From: Becky-Coel Roback [becky_cr@lanl.gov]
Sent: Wednesday, December 05, 2007 6:15 PM
To: Dhawan, Neelam, NMENV
Cc: Cobrain, Dave, NMENV; mcinroy@lanl.gov
Subject: 03-055(c) sediment sampling
Attachments: 3-055(c)_IWP_figure.pdf

Figure 5.5-1. SWMU 03-055(c) site map and proposed sample locations

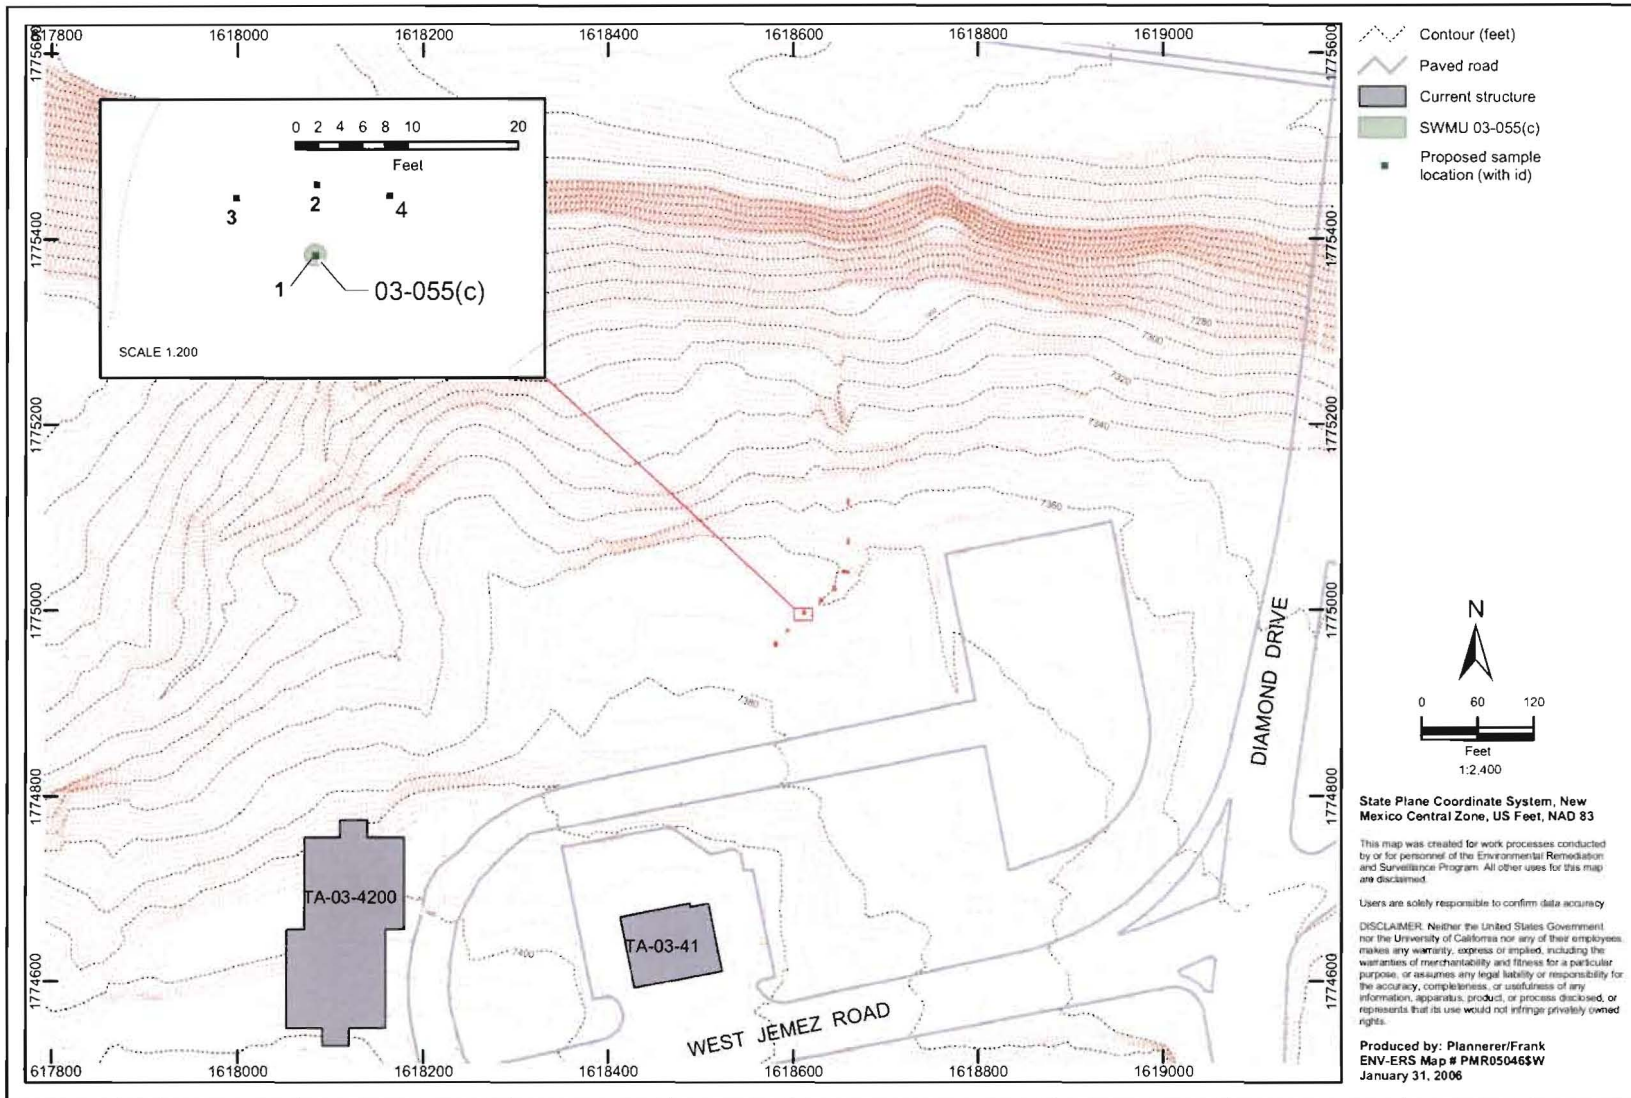
Neelam--per our conversation earlier today, attached is a slightly modified figure out of the approved Upper Los Alamos investigation work plan. The inset box shows the current sampling approach (i.e., one location downstream of the outfall, and three locations fanned out less than 10 ft downstream from that). The hand-drawn red dots on the map show an approximation of the sediment sampling that we are performing to help the Los Alamos County folks out with their road building efforts. The drainage is very narrow (~ 2 ft) and very well defined, so it seems unnecessary to fan out to determine the path of flow. There are obvious sediment pockets to the edge of the canyon slope. We would like to propose that we use this sampling approach (and in fact, these samples) because it will better characterize the downstream extent of any potential contamination. The analytical suite is the same as in the approved work plan, and we are collecting multiple depths at all locations. The number of locations/samples and length of the channel characterized are obviously greater than previously proposed. Please let me know what you think.
